Subdivision Application – RM240388-389

Seven Oaks Kinloch Ltd – Otaketake Drive and Kahikatea Drive, Kinloch

Engineering Assessment

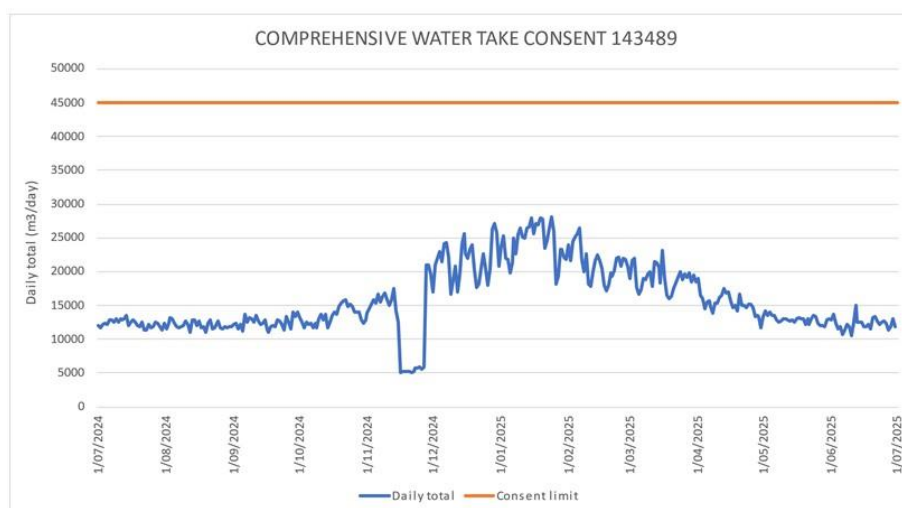
- i. The resource consent (AUTH143489.01.01) to allow water to be taken from Lake Taupō cover all of TDC's supplies from Kinloch around to Motuoapa (in an easterly direction) and is valid until 31st October 2047. Considering the volume allowed by that consent compared with the actual extraction, the below graph shows the trend for the last 12 months. It can be seen that there is at least 50% spare consented capacity.
